External appearance change of the safety controller CC-Link interface module, WS0-GCC100202

WS0-GCC100202

FA-A-0274-A

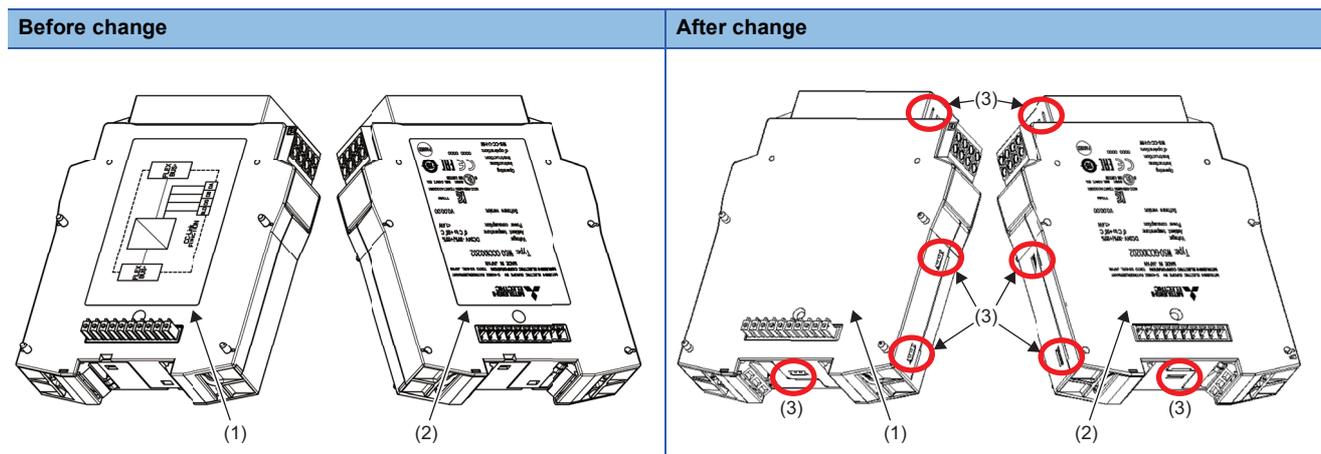
The external appearance will be changed as shown below.

(1): The block diagram label will be no longer put on.

(2): The rating plate will be changed from a label to direct printing on the case.

(Depending on the lot number, the rating plate label may be put on even after the changeover period.)

(3): The case will be changed to the claw structure.
